Memorandum

Date: April 4, 2013

Re: Station at Riverside Redevelopment
Response To Questions/Comments
City of Newton/Riverside Office
Properties

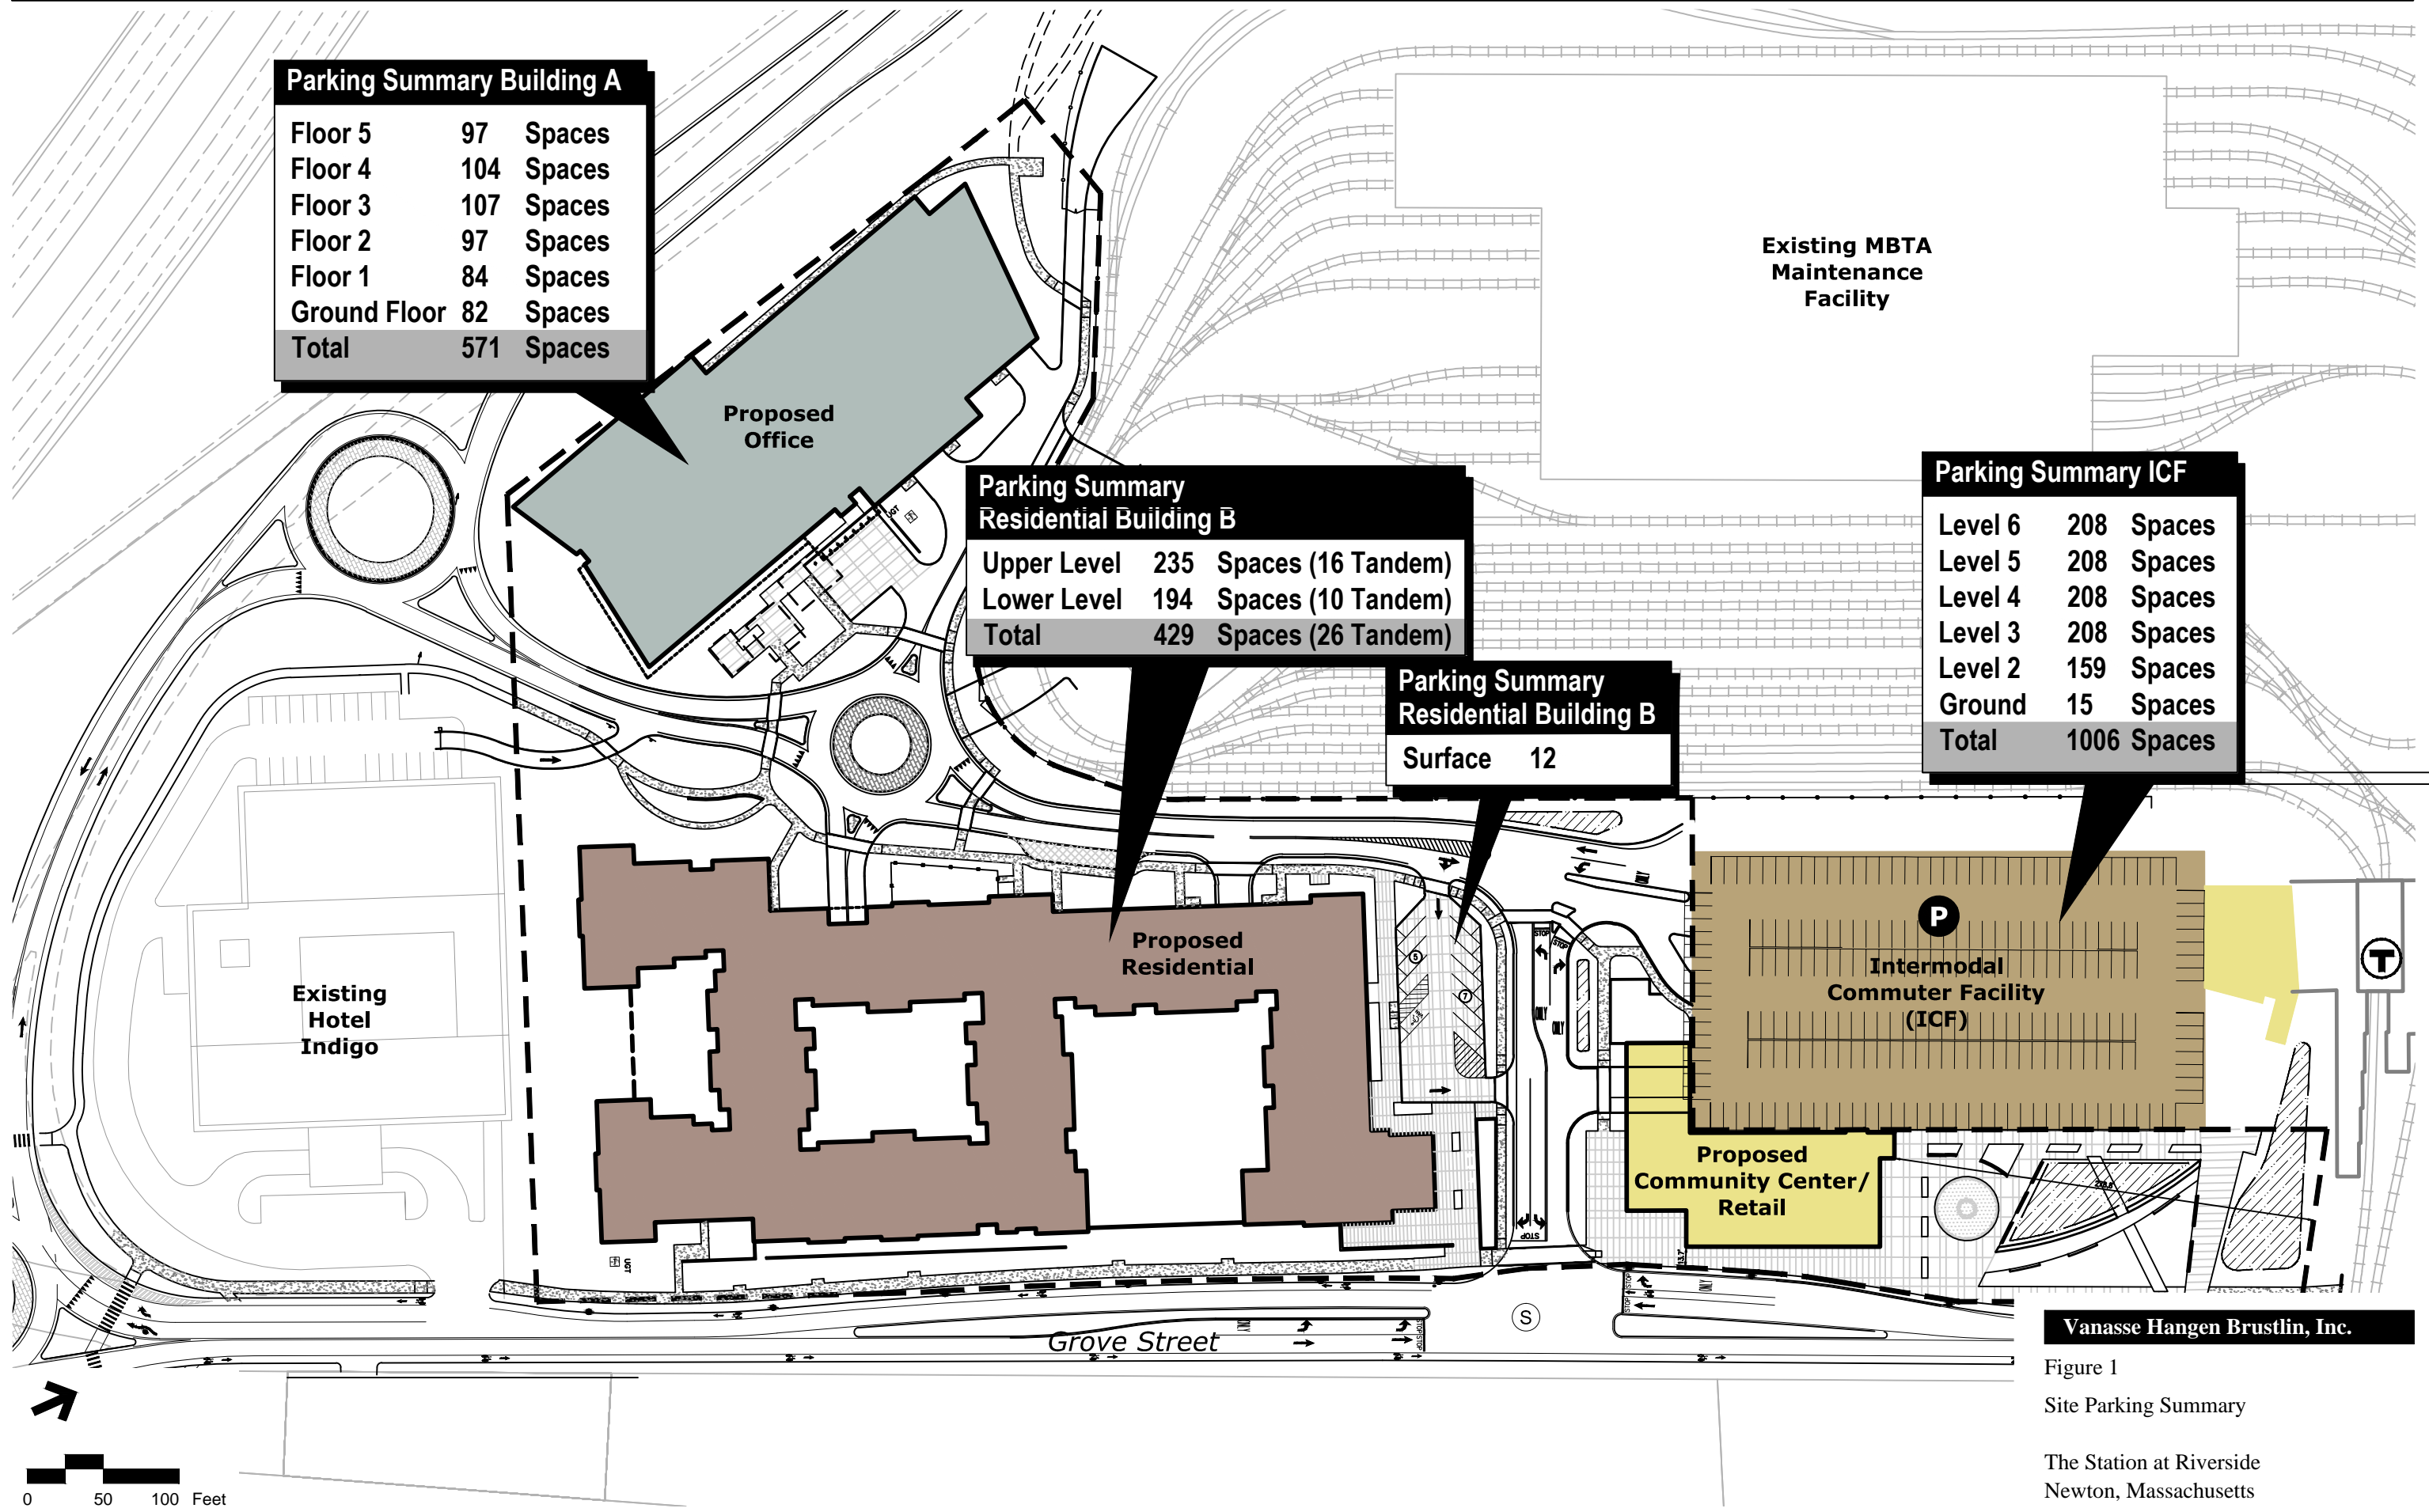
Comment: *We previously raised concerns that the unsignalized north driveway at Riverside Center would operate with long delays during the PM peak hour based on the original traffic impact analysis. The revised analysis provided by VHB, which assigns a higher share of The Station at Riverside traffic past this driveway, shows even greater delays for traffic exiting your site. Per Table 2 of the VHB memorandum the site driveway was originally expected to operate at 76 percent of capacity with average delays of 77 seconds per vehicle. The revised analysis shows operations deteriorating with an average delay of 117 seconds and a volume-to-capacity ratio of 90 percent. Furthermore, analysis results shown in Table 1 for the adjacent signalized center site driveway intersection with Grove Street indicate a 95th percentile queue on Grove Street southbound of 373 feet. This queue would block your north site driveway located only 225 feet away. (Even longer queues, in excess of 500 feet, are predicted for the morning peak hour however, more limited traffic volumes exit your site at this driveway during the AM peak hour.) No detailed discussion of this condition has been provided by the applicant nor have any mitigation measures been proposed.*

We have not seen any detailed discussion of this intersection and possible mitigation measures.

Response: Regarding the potential blockage of the north site driveway, it should be noted that under Existing conditions, the 293 foot queue from the center driveway currently blocks the north driveway, so this condition is not caused by the Project. There is no increase in overall delay or the delay for the southbound movement as a result of the project. Furthermore, this movement operates at LOS A with only 6 seconds of delay, and the 95th percentile vehicle queue will clear the intersection in one signal cycle.

Figure 2
Site Bike Parking Summary

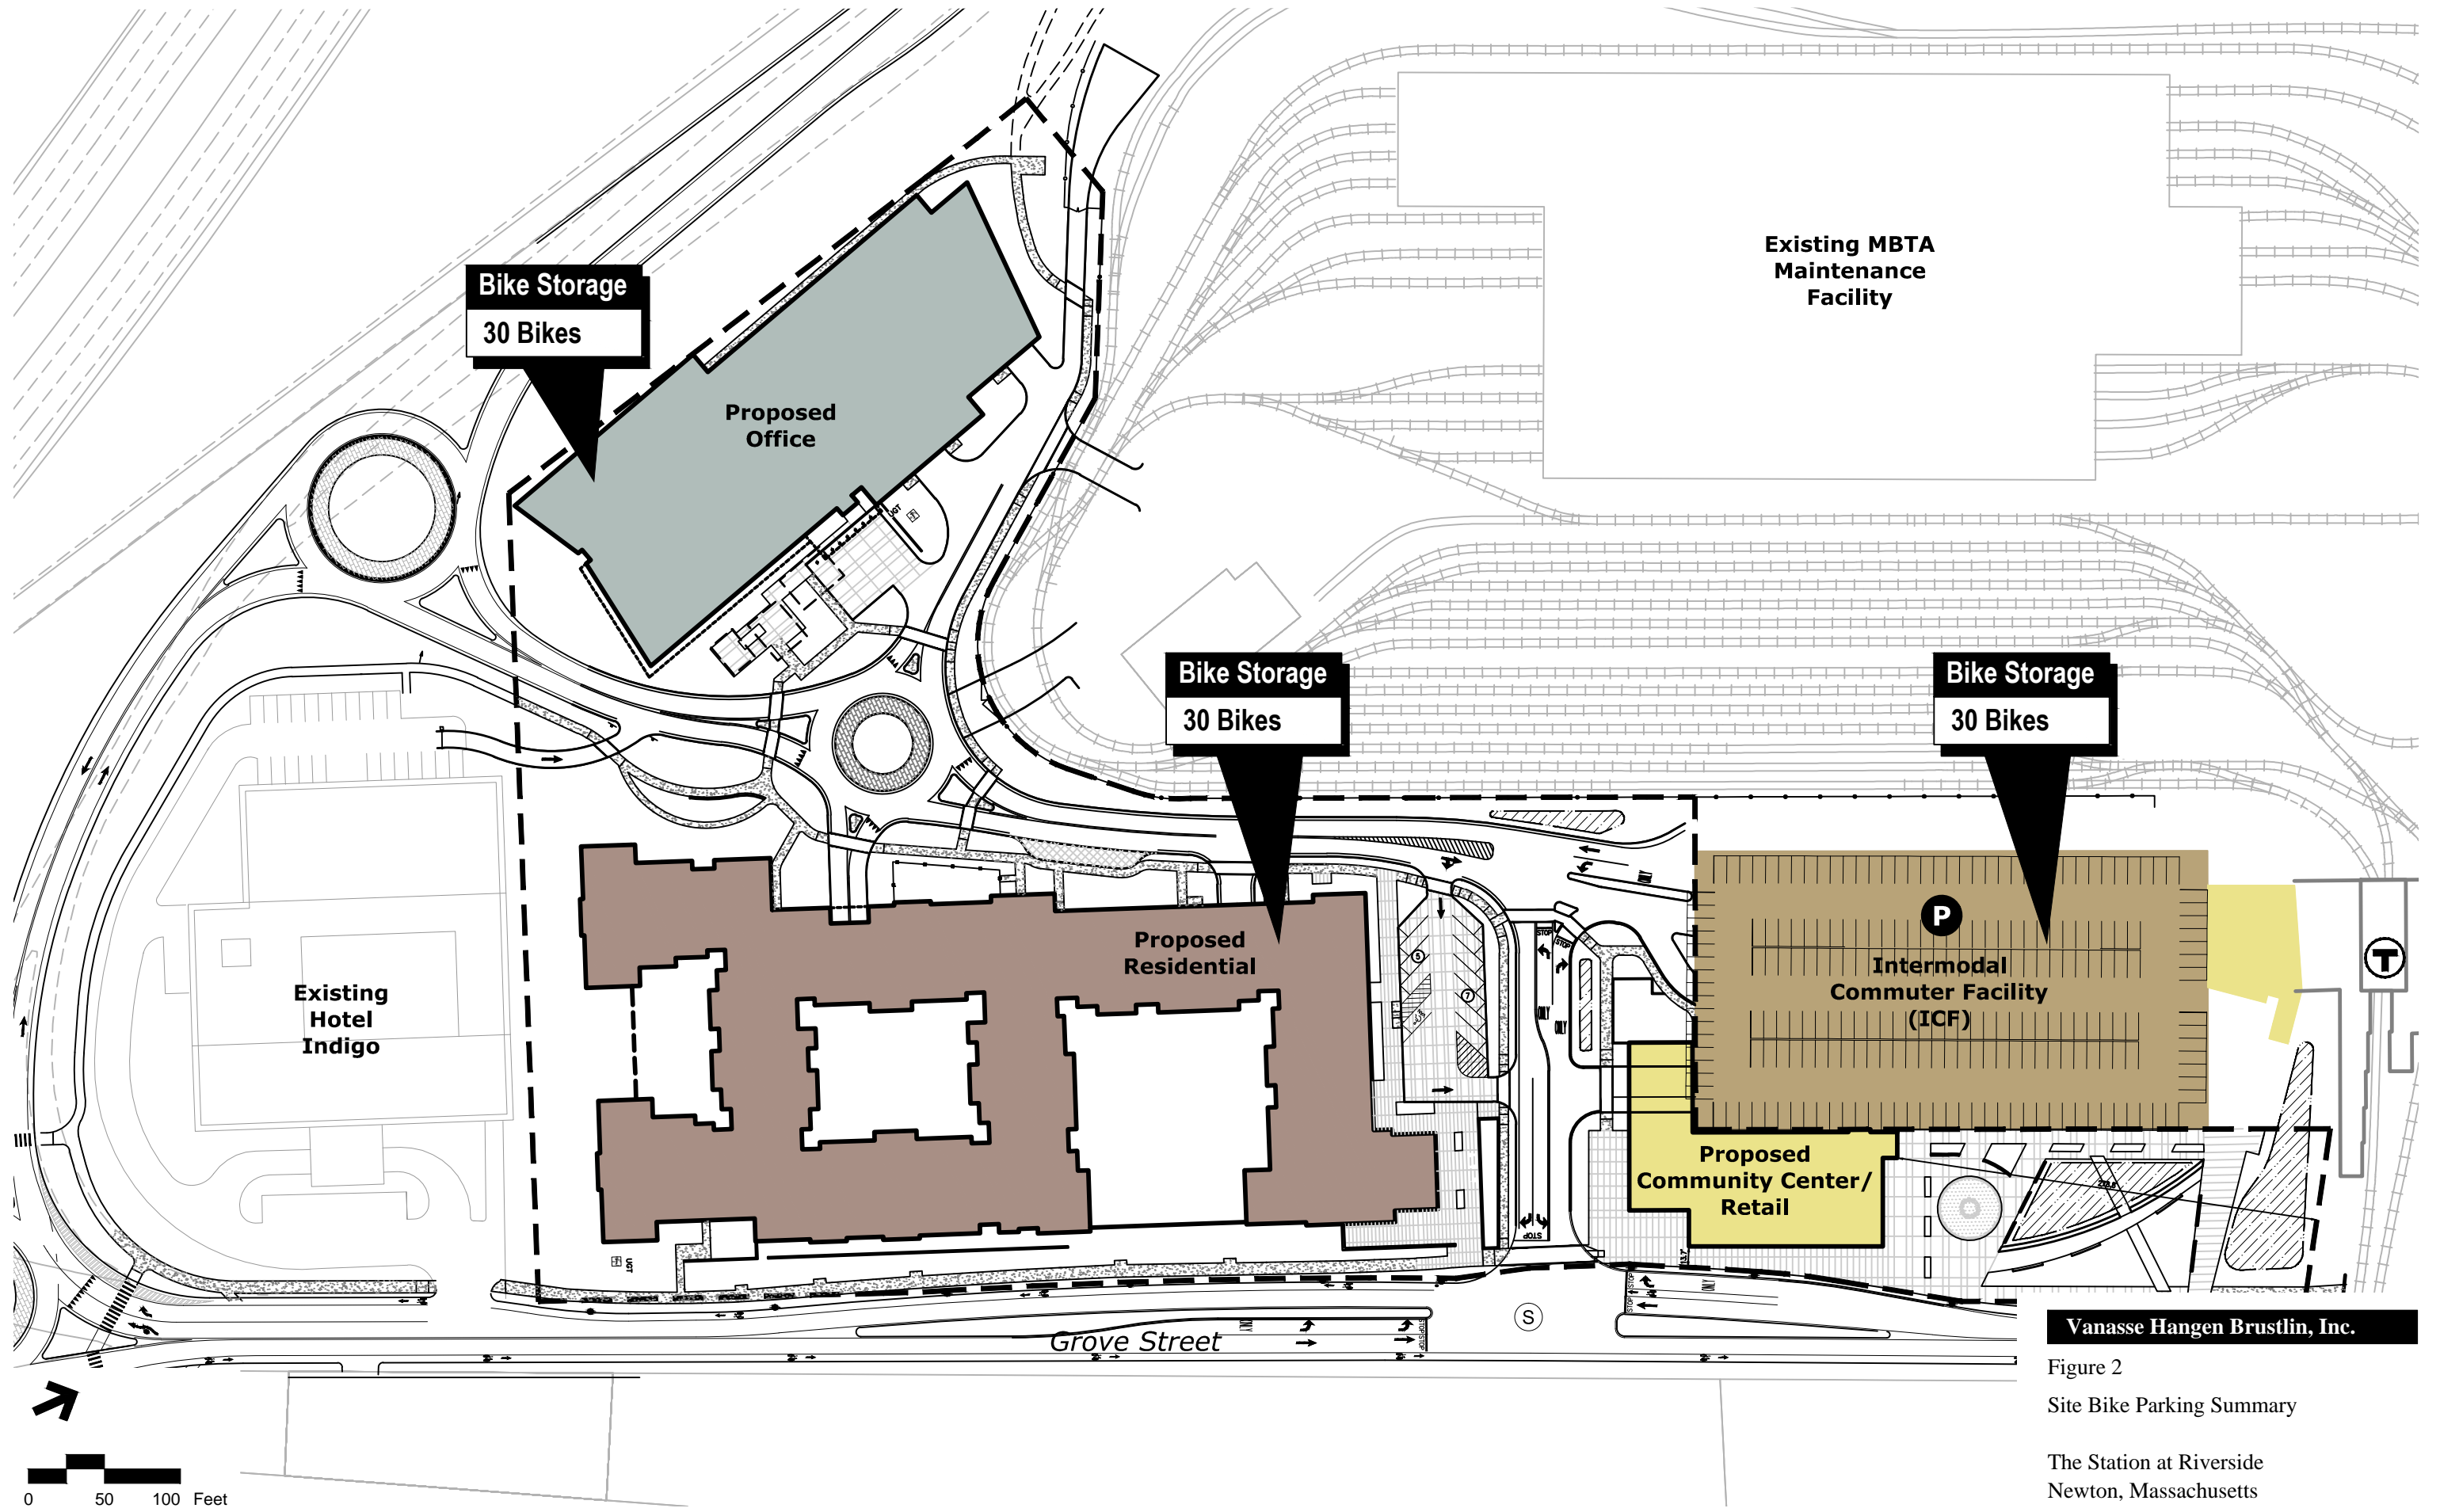
Comment: *Bikes. Provide total number of bike spaces*

Response: Per the Newton Zoning Code requirements, a minimum of 30 bicycle parking spaces will be provided within the Office, Residential, and ICF facilities (see attached Figure 2). Bike storage will provided along the south west side of the building (Building A). Inside bicycle storage will be provided at the northeast corner of the residential building. And an internal bicycle storage cage, will be provided on the ground floor of the ICF. Additional bike racks will likely be added to key areas including in proximity to the proposed retail as well. Locations of primary bike accommodation on site is identified in figure format in the attachments.
